MINOR VARIANCE REPORT

APPLICATION: CAV A/165/2024

CAV A/165/2024 - 21 Pebbleridge Place (West District) (OP Designation: Low Density Residential – Special Policy Area)

Proposed Front Elevation – 21 Pebbleridge Place

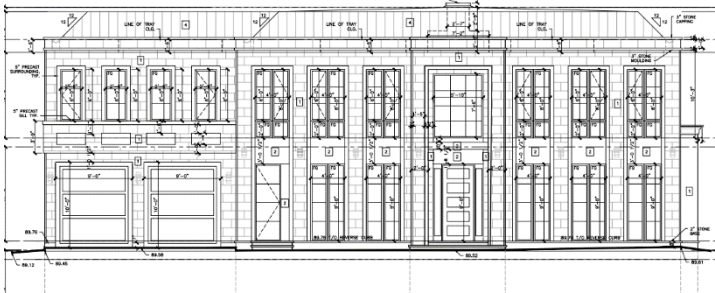
The subdivision consists of larger lots with larger homes. The front elevation of the proposed dwelling is shown in the figure below.

Staff are concerned that the requested variances would result in an overbuild of the property, and cumulative negative impacts on the streetscape. On this basis, it is Staff's opinion that the variances do not maintain the intent of the Official Plan as the and would result in a dwelling that is not in keeping with the character of the neighbourhood.

Second Storey Floor Plan – 21 Pebberidge Place

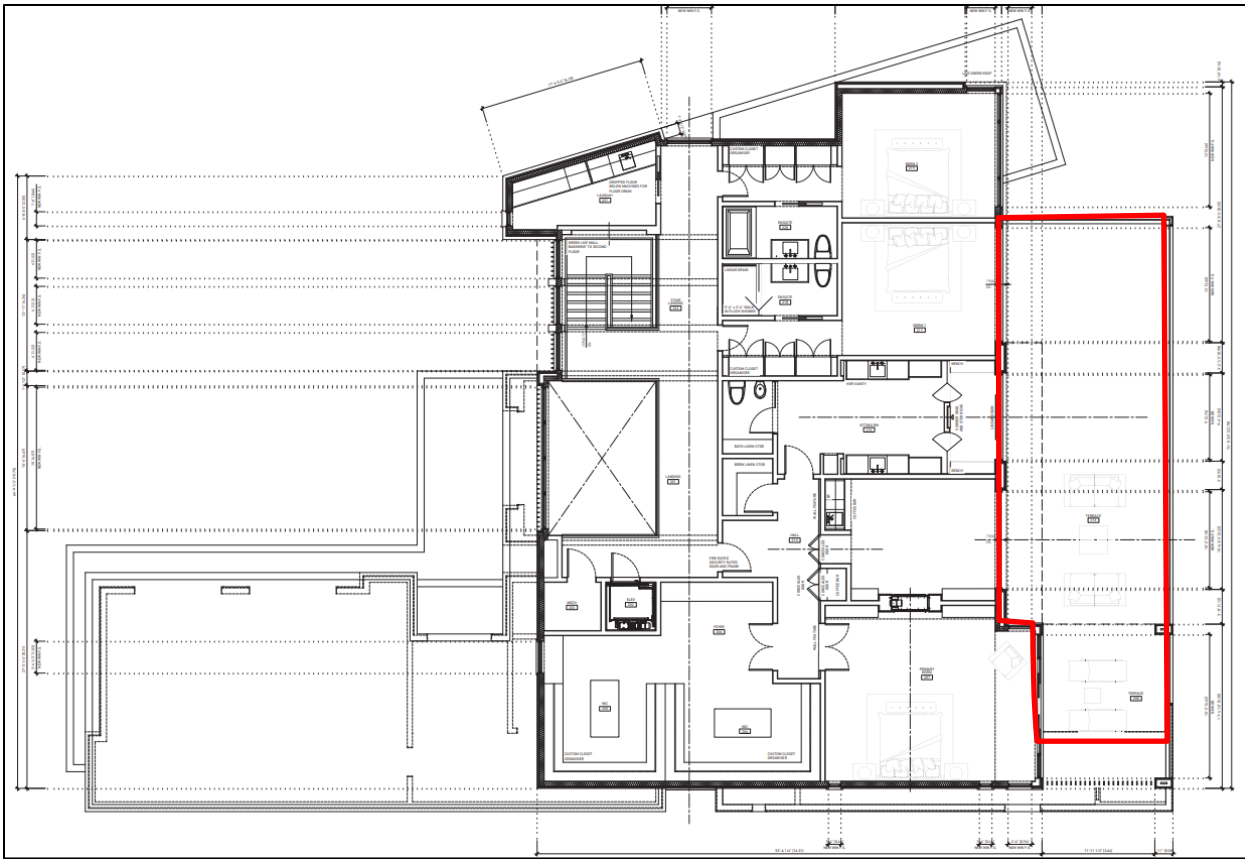
Variance #1 – Rooftop Terrace in -0 Suffix Zone (Objection) – Not permitted to permitted in the RL1-0 zone

Variance #2 – Rooftop Terrace Depth (Objection) – 1.5m increased to 5.57m

The intent of regulating a rooftop terrace in the -0 Suffix Zone is to prevent potential overlook and privacy impacts. The intent of regulating maximum total rooftop terrace depth is to limit the impacts of overlook and privacy concerns in zones where rooftop terraces are permitted. The proposed rooftop terrace as outlined in red in the second storey floor plan below, is substantial in size with an area of approximately 93.00 m² and projects 5.57m into the rear yard beyond the main wall of the dwelling. It is staff's opinion that introducing an element that has been identified as not permitted in the Zoning By-law would not meet the intent and purpose of the Zoning By-law, and would contribute to the cumulative impacts of the variances proposed resulting in an overbuild of the subject property.
